March 6, 2026

Re: Second Peer Review of the Stormwater Design
100 Old River Road, Andover, Massachusetts
MassDEP File No. 090-1459

Figure 1. Screenshot of plan sheet showing BVW boundary in blue with associated linear measurements for portions of it segmented via vertical red markers; approximate extent of buffer zone mitigation plantings shown in green; 50-foot buffer zone in orange

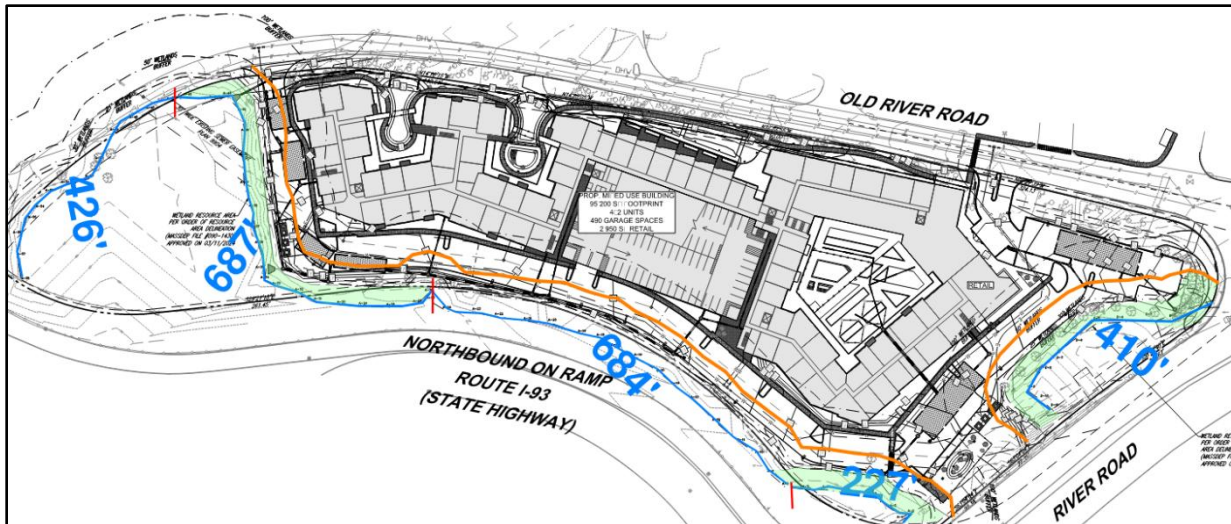
(approximately 46%). Figure 1 within Section 2.0 provides a map of the areas where invasive species were identified, which encompasses the entire area surrounding the proposed re-development within the parcel. No plantings are proposed for the approximately 684-foot length section indicated in Figure 1 below.

Additionally, it appears that invasive species were not assessed for the entire extent of the 0-25-foot Buffer Strip that exists on the subject parcel, which exists between the roadways (i.e., Old River Road and the ramp to Route 93 Northbound) and the BVW in the northwestern portion of the parcel (see Figure 1 below).

14. HW recommends that the Applicant clarify the language in the narrative to accurately represent the extent to which mitigation is proposed¹.

The extent of buffer zone mitigation plantings does not encompass the entire 0-25 foot Buffer Strip in two of the three areas approximated in Figure 1 above, as portions of these areas appear to be as narrow as 12 feet wide (see Figure 2).

March 6, 2026: The Applicant has updated the language as suggested. No further action is requested.
